Re: **Site Plan Review Freestanding Sign Illumination**
489 Granby Rd.
South Hadley, Ma. (01075)

SITE PLAN
FOR
489 GRANBY ROAD
SOUTH HADLEY, MA.

D-2

PROPOSED MONUMENT SIGN
NOT TO SCALE

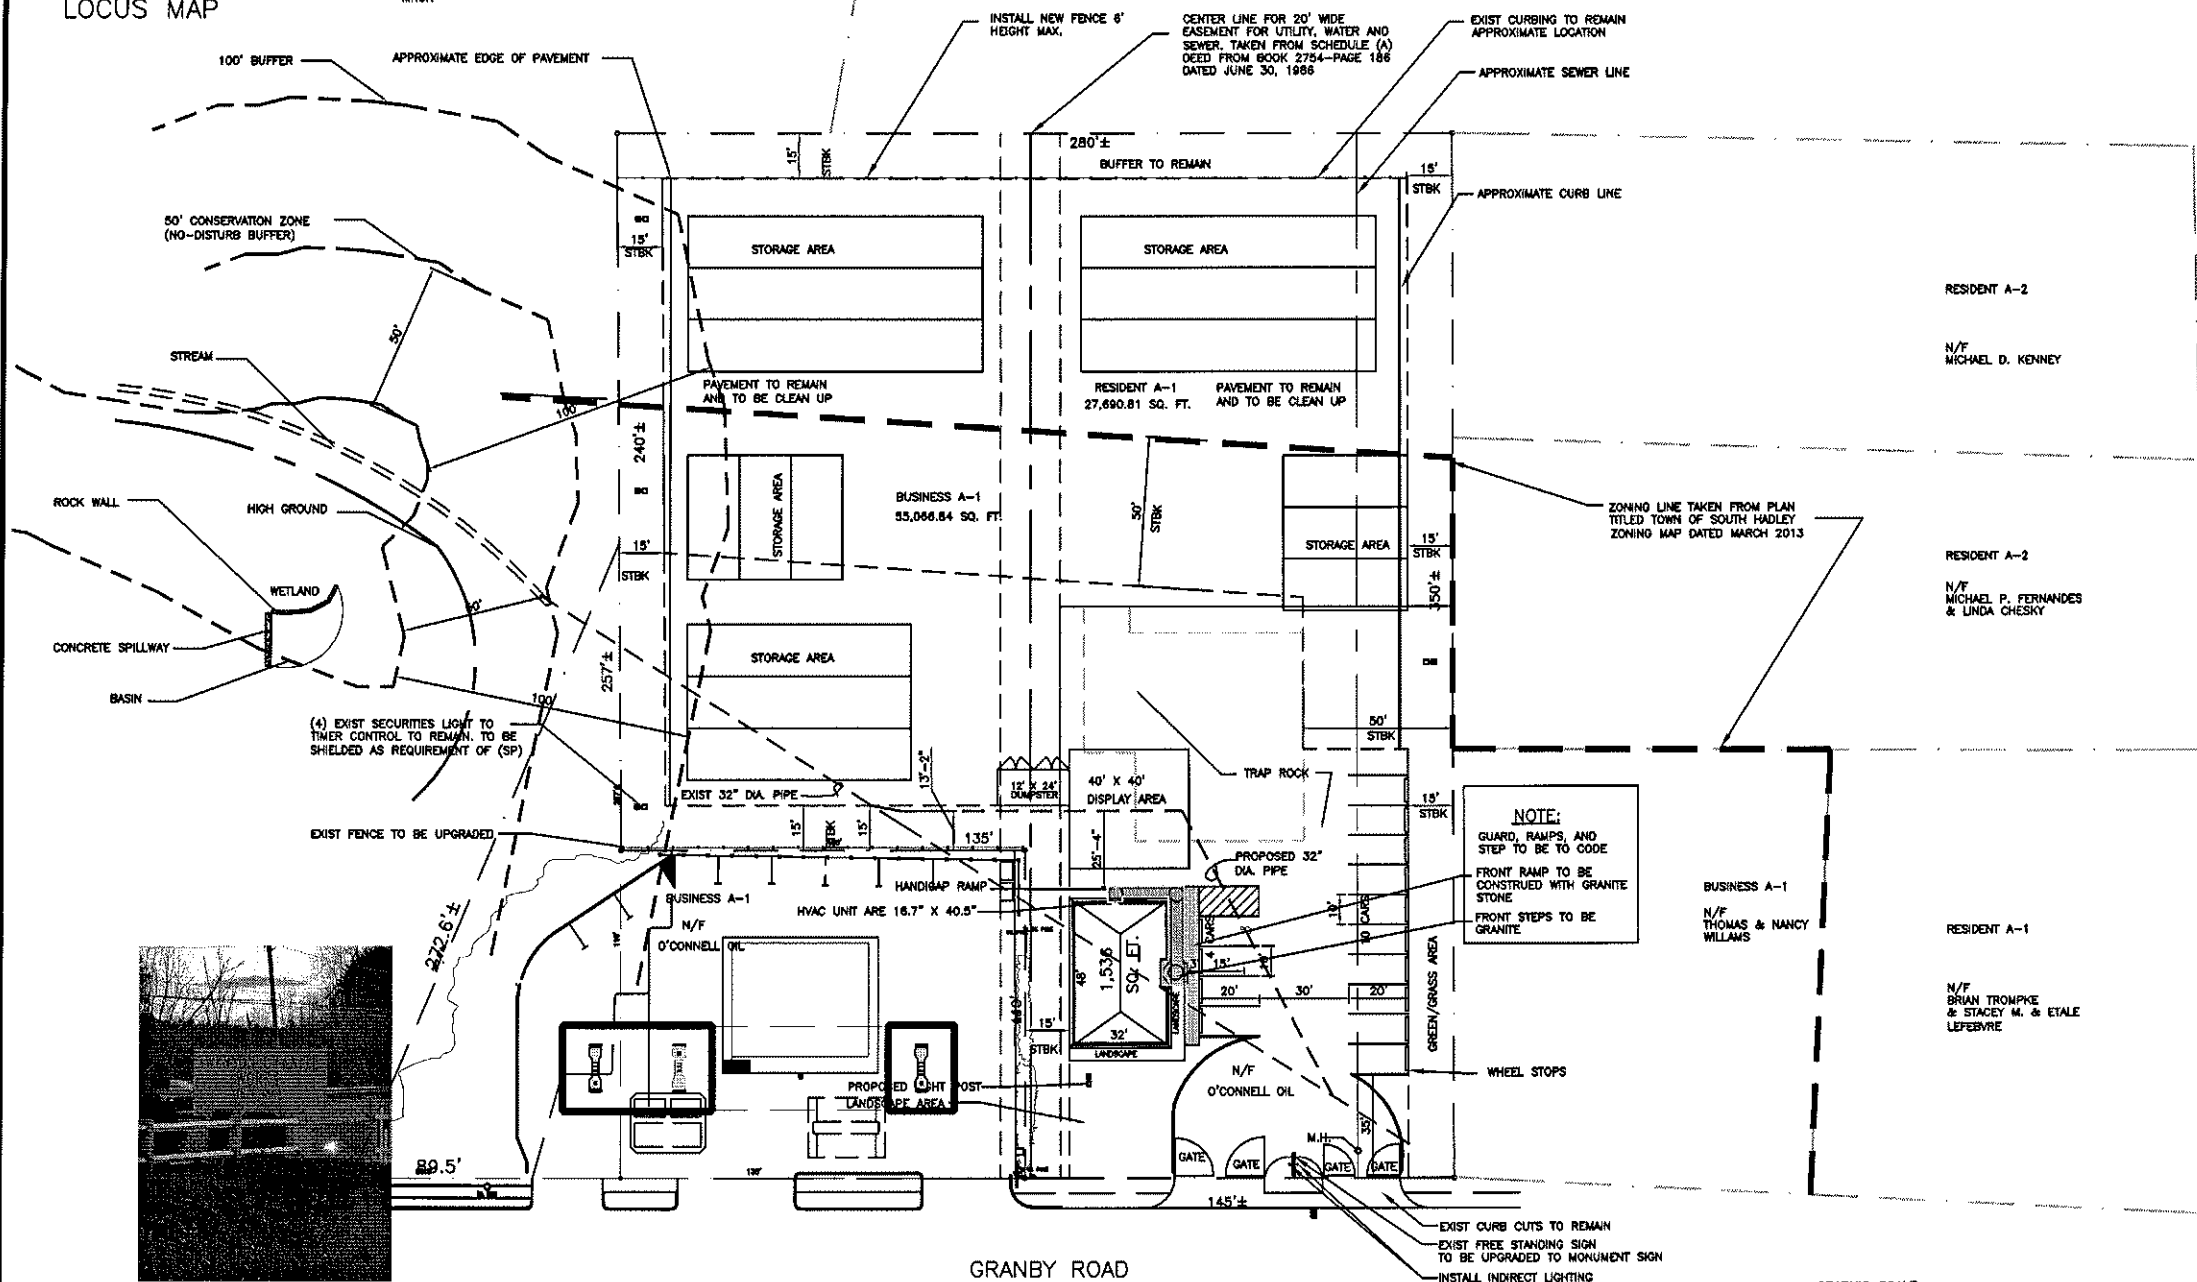
At this time we are requesting the approved "freestanding sign" location per SPR submission plan Dated 3-22-2017 to be illuminated, which was absent at submission. Plan note #6 states a 36 square foot sign. See also photos enclosed. A Two sided solid granite sign installed perpendicular to the road resting on two granite uprights will be 4'x 9' and not to exceed 10' in total height.

- Illumination to be by LED Pedestal Lights
- Lighting to be from Dusk to Midnight. -
